ERRATA NOTE

CC1110Fx/CC1111Fx

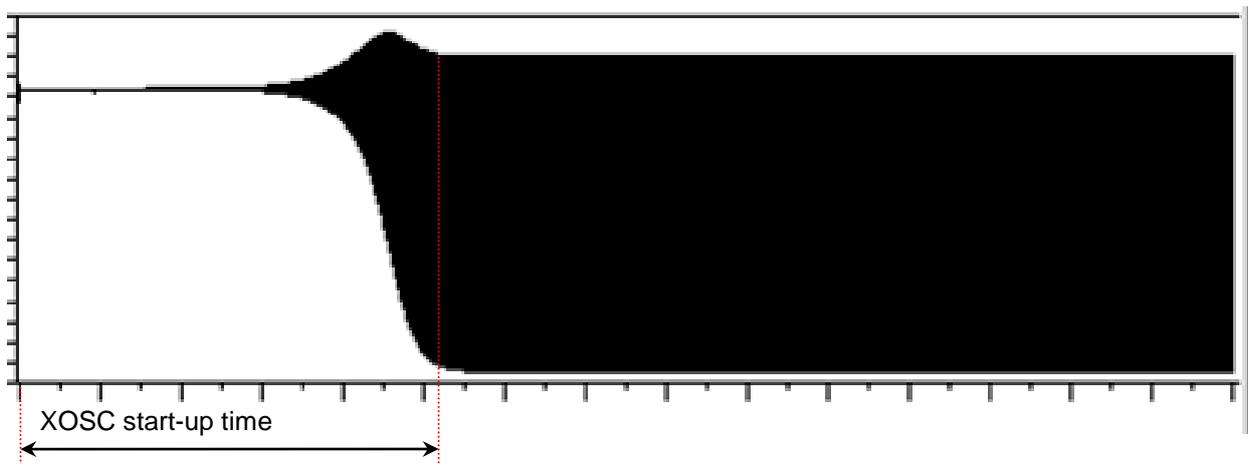
The XOSC_STB signal (crystal oscillator stable signal) is derived from an internal ripple counter, which counts clock pulses during oscillator start up. Due to the very small oscillation amplitude during the initial crystal start up, the ripple counter can in some cases trigger on power noise instead of the actual crystal swing, and there is a finite possibility that the ripple counter used to set XOSC_STB can assert XOSC_STB prematurely.

If the HS XOSC is turned on by selecting it as source for the system clock (CLKCON.OSC = 0), CLKCON.OSC will remain 1 (and keep the HS RCOSC as source) until the SLEEP.XOSC_STB bit is asserted. In the cases where XOSC_STB is asserted prematurely the system clock will change clock source prematurely and end up running on an unstable clock causing unpredictable behavior.

The figure below shows the XOSC_Q1 pin as the crystal is turned on. When measuring on XOSC_Q1 one needs to use a high impedance probe to avoid loading the crystal.

The HS XOSC must be turned on by setting SLEEP.OSC_PD = 0. A SW delay should then be implemented to make sure the crystal is stable before selecting the HS XOSC as system clock (CLKCON.OSC = 0). The SW delay has to be greater than the maximum start-up time of the crystal.

When finding the max start-up time one should measure on several crystals over temperature. A 100% margin should be added to the measured start-up time to account for process variations.
